Responses to ECORP Third-party Review Comments on the Draft Mitigated Negative Declaration for the Bridge Point Upland Project

This document includes a reproduction of, and responses to, comments received by ECORP Consulting, Inc. provided in a letter memorandum dated January 31, 2020.

Refined Airport Compatibility Zone Figure

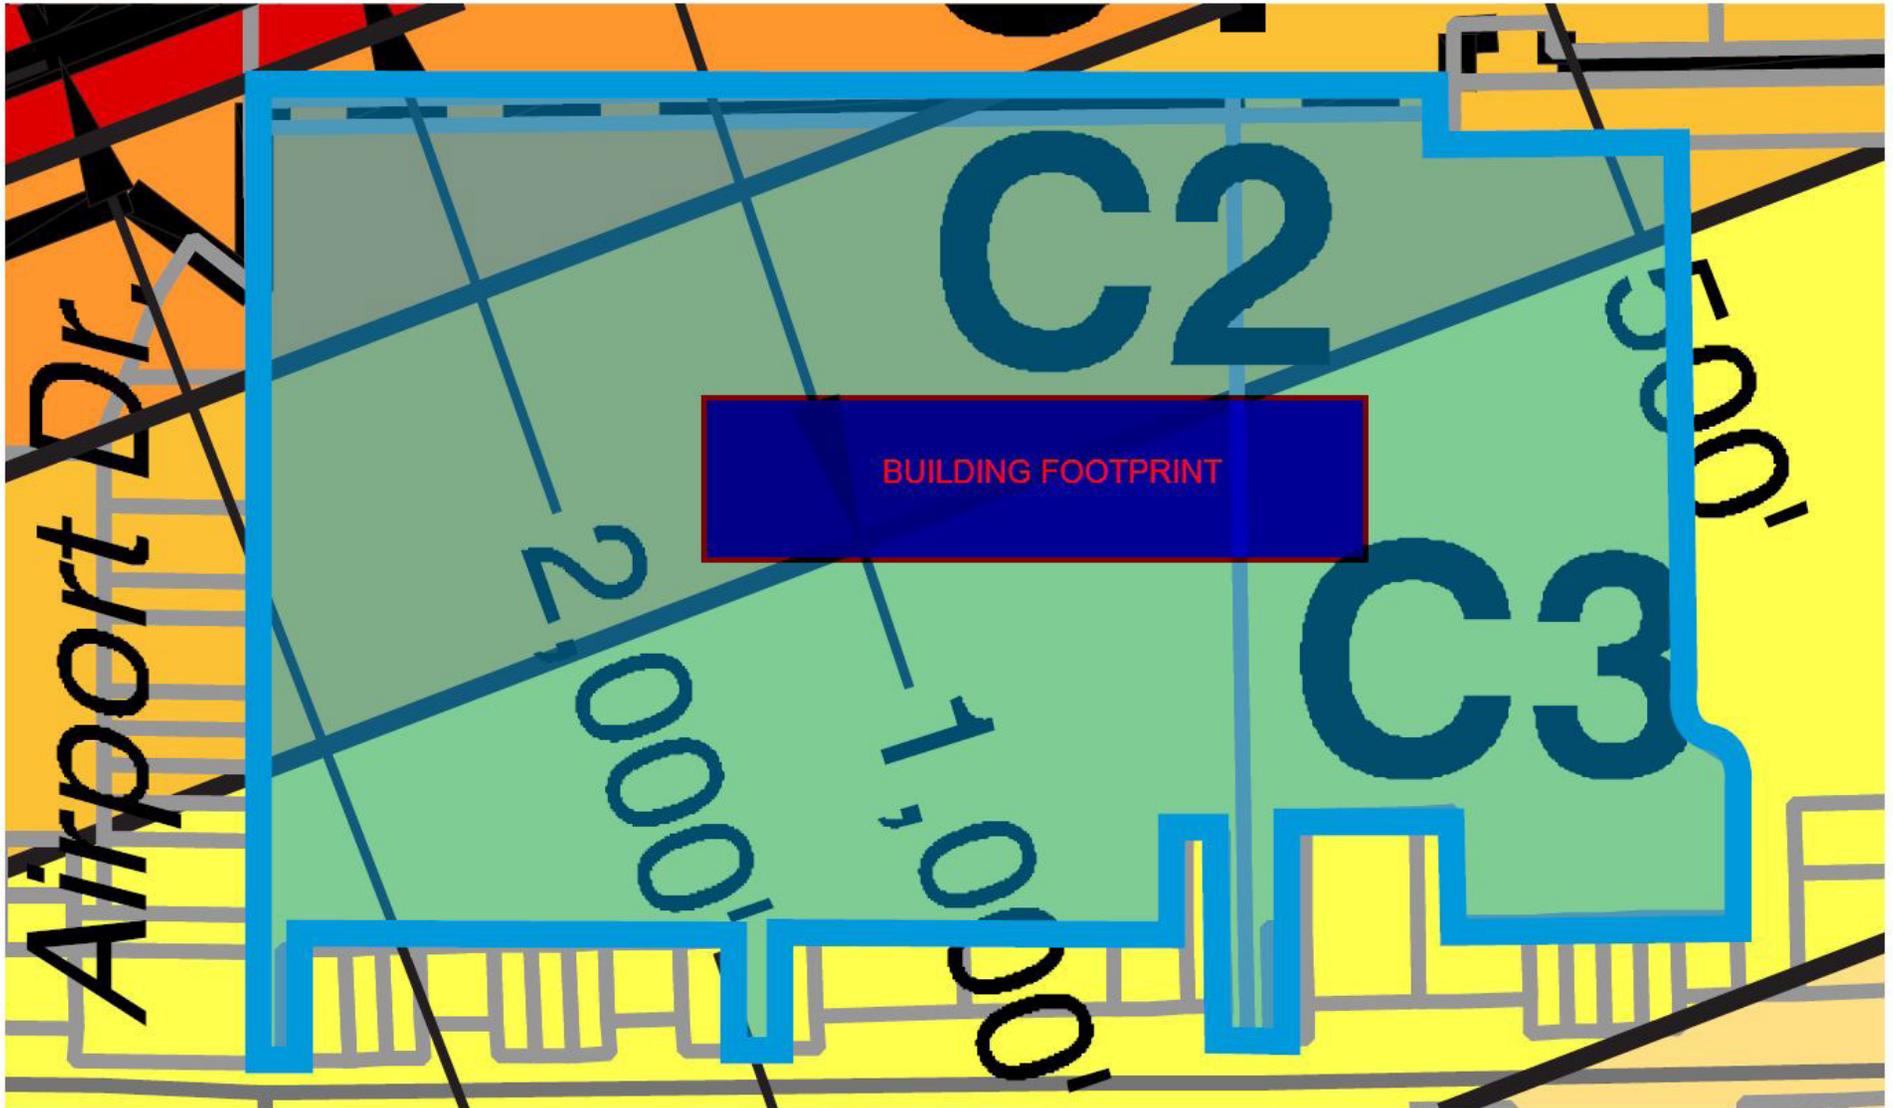
E-10	Geology and Soils. Reliance upon conformance with the Geotechnical Investigation Report as mitigation for identified soil conditions is appropriate. If available, evidence should be provided of depth to groundwater if encountered with boring at the site.	As noted in the 2019 Geotechnical Investigation prepared for the Project (Appendix C-1 in the Draft IS/MND), groundwater was not encountered during the borings and excavations conducted for the Project site. Therefore, groundwater is assumed to be present at depth in excess of 10 feet.
E-11	Hazards and Hazardous Materials. The response to issue a) regarding routine transport, use, or disposal of hazardous materials, would be strengthened with an explanation as to why hazardous materials associated with operation of warehouse/parcel delivery service facility are differentiated from a traditional warehouse facility, which may involve transport and storage of hazardous materials other than the common hazardous materials listed (i.e. cleaners, paints, solvents, fertilizers and pesticides). This would provide additional support for impact conclusion for issue areas b) and c) that follow. With regard to issue e), to respond to public comments concerning Project location within Airport Compatibility Zones C1, C2, C3, a Figure 4 enlargement of these zones, the project	The proposed project will be a Last Mile warehouse providing direct delivery of commercial goods to the residents in the City of Upland and the surrounding area. Therefore, operations would not include the transport of hazardous materials other than the small amounts of household cleaners, solvents, and other household goods that may be purchased and delivered legally by consumers. As discussed in threshold VI. 9 (a) of the Draft IS/MND, the proposed Project would adhere to federal, State, and local health and safety requirements regarding the handling, transport and disposal of hazardous substances. A figure showing the building footprint in relation to the Airport Compatibility Zones has been added to the Final IS/MND as Attachment E-2 of this document.

Attachment E-3A: Aerial and Map Views of Very High Fire Hazard Severity Zone

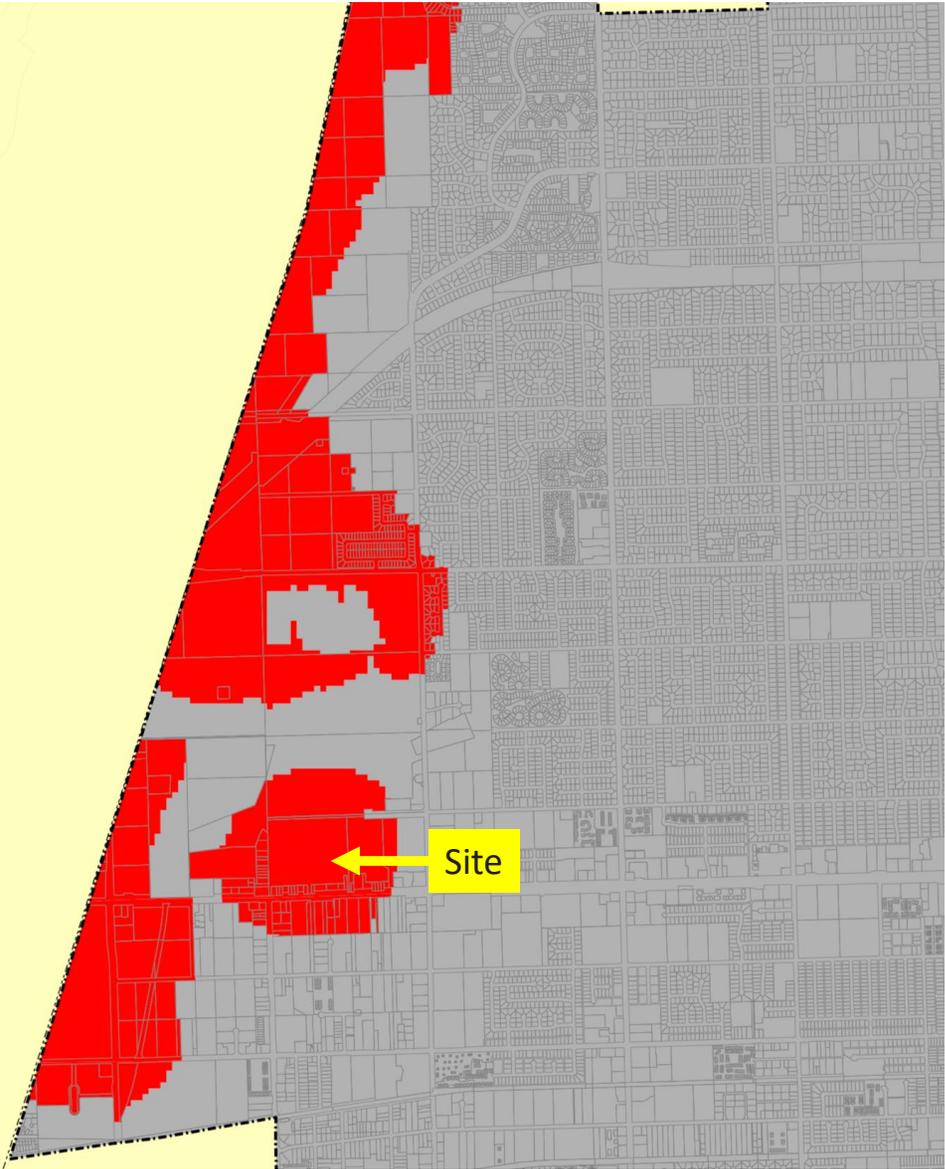
E-20	Tribal Cultural Resources. Compliance with AB 52 is demonstrated through the discussion of issue a) i and ii, and Mitigation Measures CR-1 through CR-7.	Comment noted.
E-21	Utilities and Service Systems. The impact conclusions of Less than Significant for issues a) through f) are adequately supported by the analyses.	Comment noted.
E-22	Wildfire. The impact conclusions of Less than Significant and No Impact for issues a) through d) are adequately supported by the analyses. Why is the Project site included in a Very High Fire Hazard Severity Zone (VHFHSZ) on the LRA Map and General Plan Exhibit 5.14.-1?	See response E-11 above. The Project area is in a predominately developed area consisting of industrial and commercial uses. The site itself is not developed with any structures. As explained in a CalFire Fact Sheet released when the Local Responsibility Area map was updated in 2007 and available online here: https://www.sccgov.org/sites/dpd/DocsForms/Documents/Fire_Hazard_Zone_Fact_Sheet.pdf “[t]he Fire Hazard Severity Zones identify fire hazard, not fire risk. ‘Hazard’ is based on the physical conditions that give a likelihood that an area will burn over a 30 to 50-year period without considering modifications such as fuel reduction efforts.” One of the fire hazard elements is vegetation and “[f]ire hazard considers the potential

Comment Number	Comment	Response
		<p>vegetation over a 30- to 50- year time horizon. Vegetation is ‘fuel’ to a wildfire and it changes over time. As seen in the Attachment E-3A and E-3B, the Very High Fire Hazard Severity Zone in Upland coincides directly with parcels that are not developed and have some level of wild vegetation that could be fuel to a fire. Moreover, as seen in the attached airphoto from 2007 when the LRA map was created, the Project site was covered with significant wild vegetation. The Project would redevelop the site and any potential wild vegetation that remains after Upland Rock clears the majority of the site, and could be fuel to a fire, would be removed from the site. Vegetation remaining onsite after construction of the Project would be maintained landscaping. This reduction in wild vegetation would reduce the fire hazard and will therefore result in a less than significant impact.</p>
